Application for Planning Approval

DA2026/022

39A ANDREW STREET, BRIGHTON

MULTIPLE DWELLINGS (1 EXISTING, 34 NEW) & ASSOCIATED INFRASTRUCTURE

5 SUN SHADOW DIAGRAM_1300PM
Scale 1:600

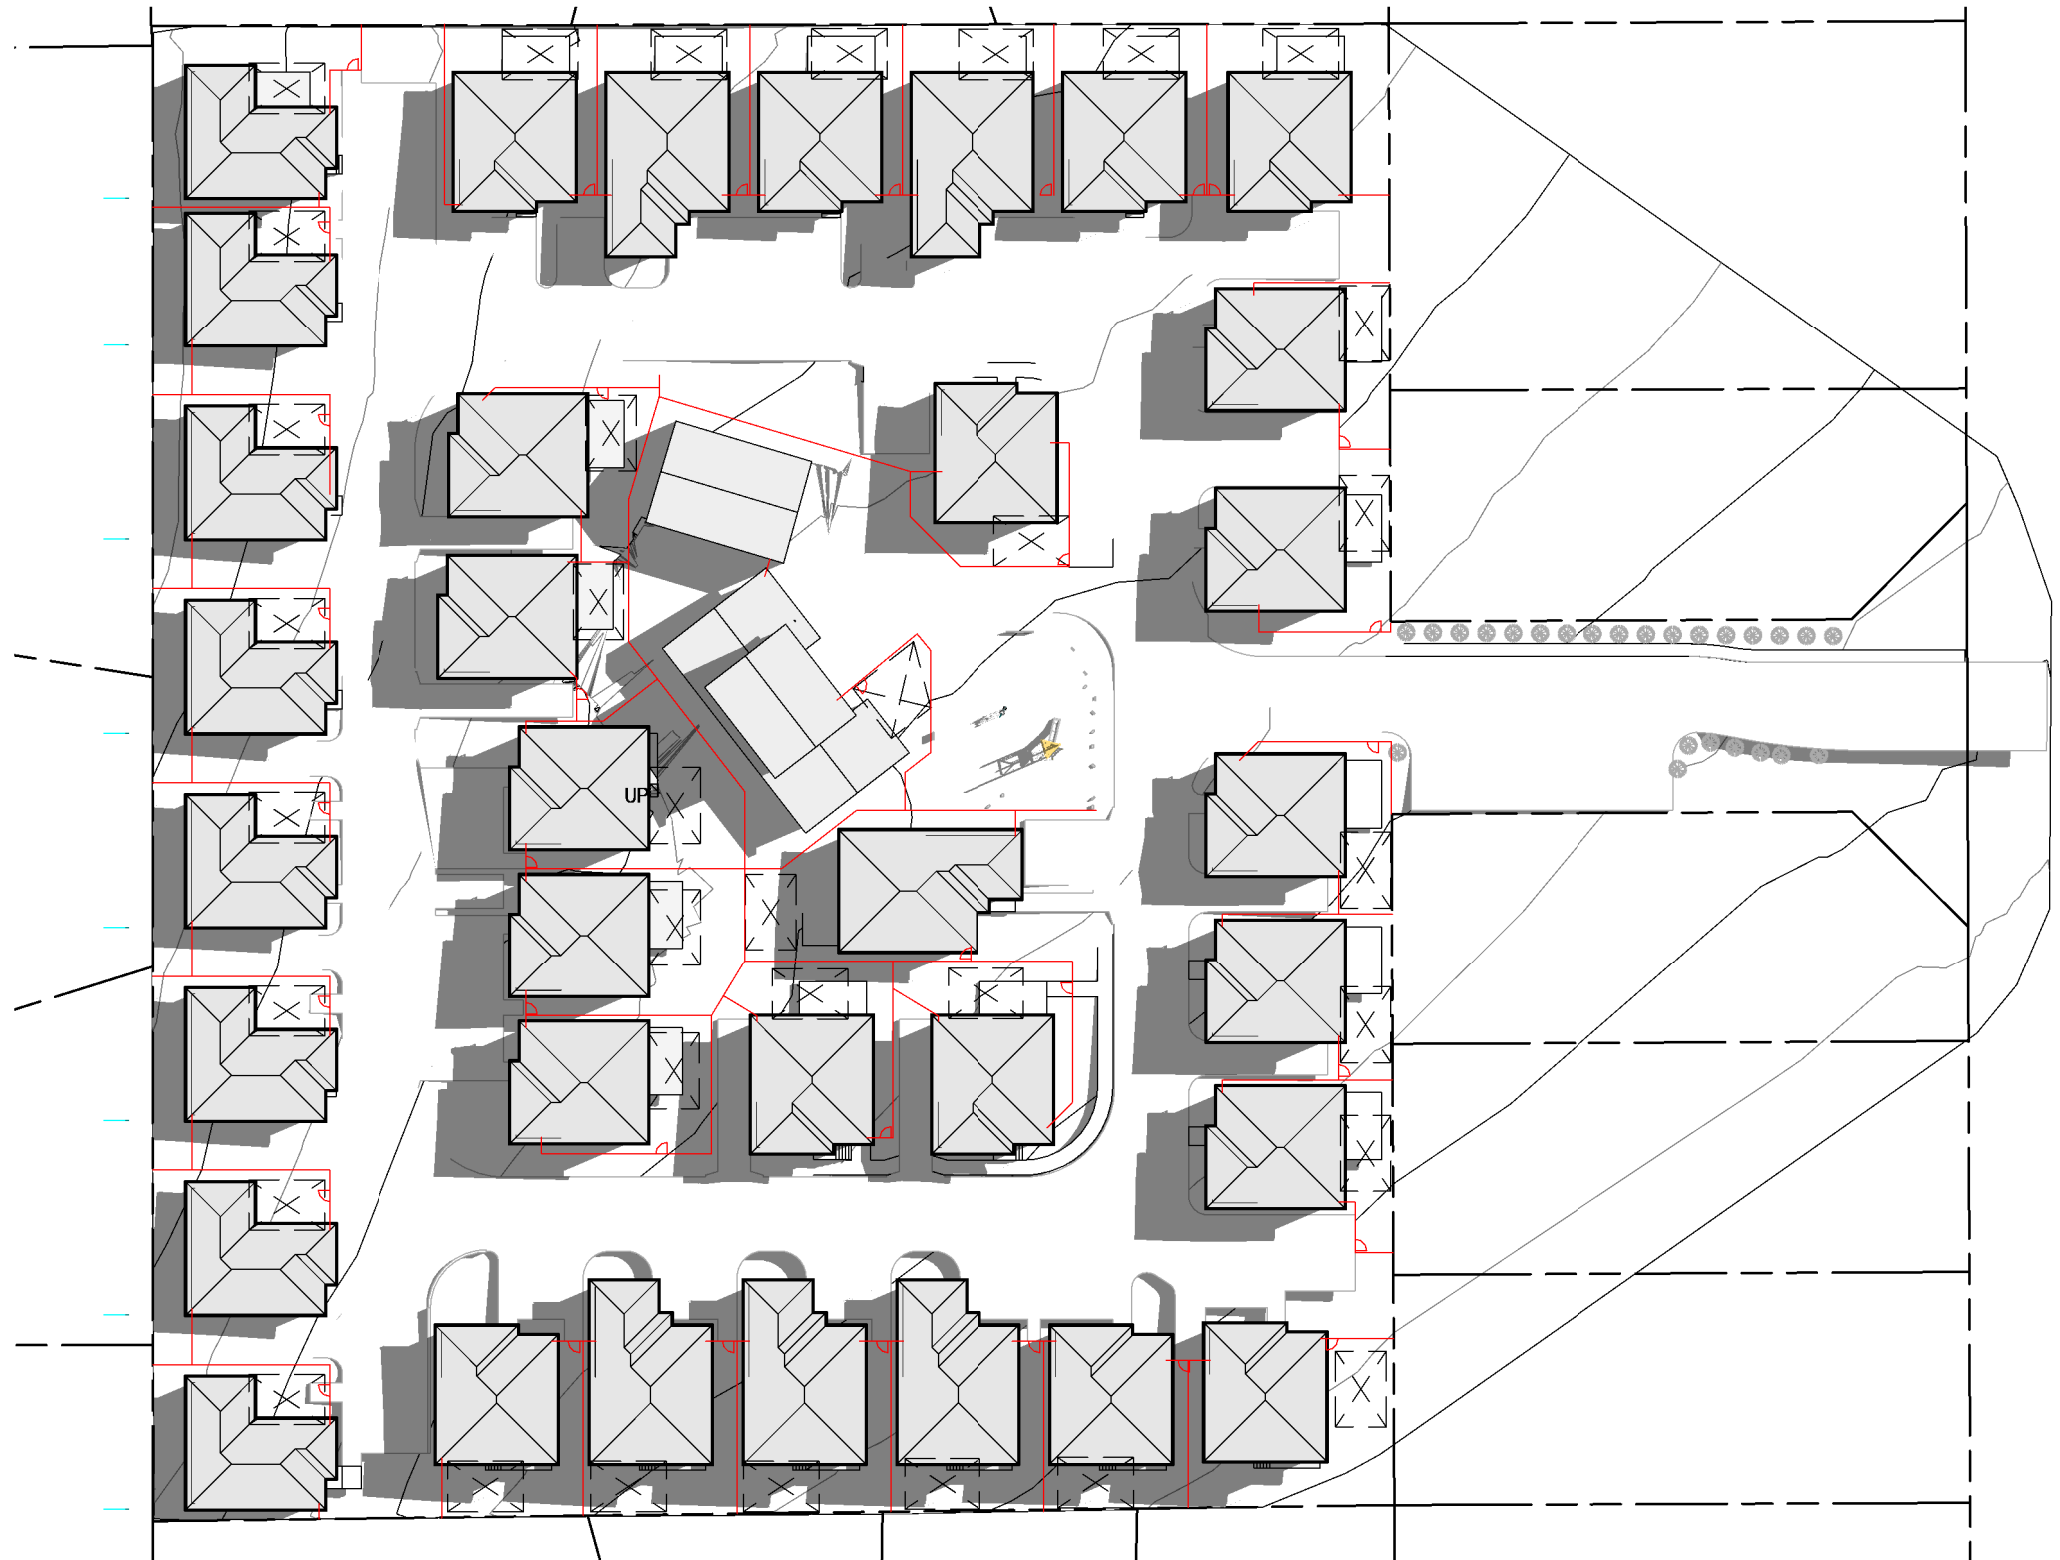
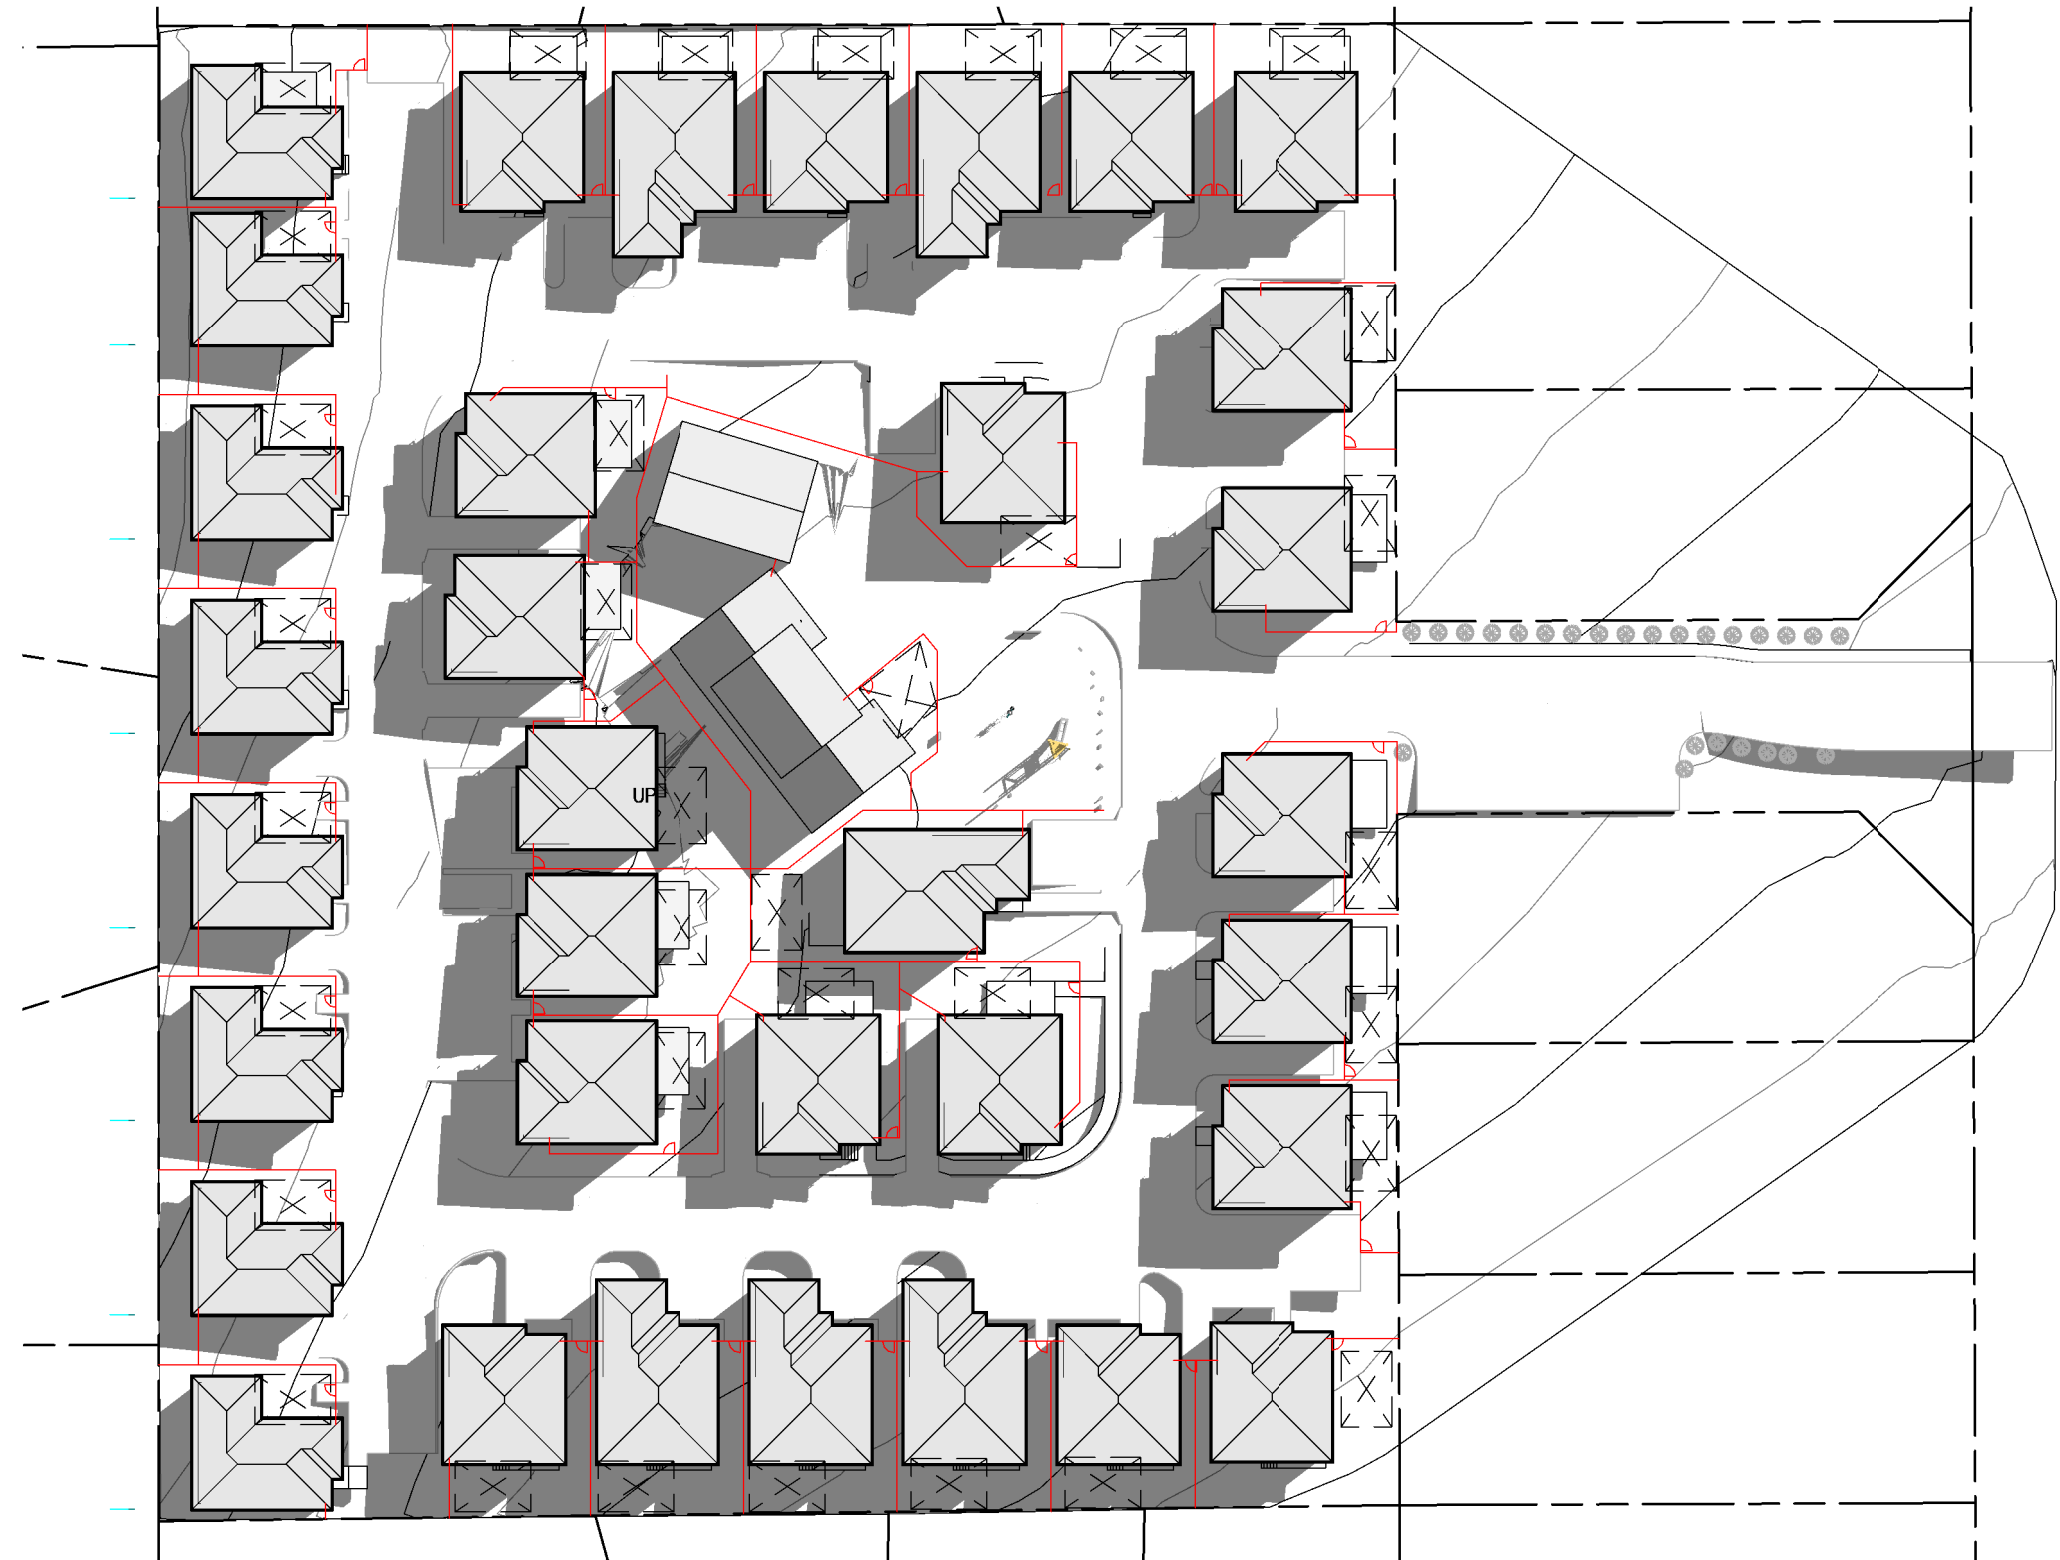
Please provide a planning report addressing each of the development standards, and where the proposed application does not satisfy the acceptable solution (eg 8.4.2 A1; 8.4.2 A3; 8.4.4 A1), include a written response to the performance criteria.

8.4.4 – A1 – The shadow diagrams provided in Drawing DA20 demonstrate that all proposed units (POS) will receive a minimum of 3 hours of direct sunlight between 9:00 am and 3:00 pm on 21 June. Accordingly, the proposed development satisfies the requirements of Acceptable Solution 8.4.4–A1(b).
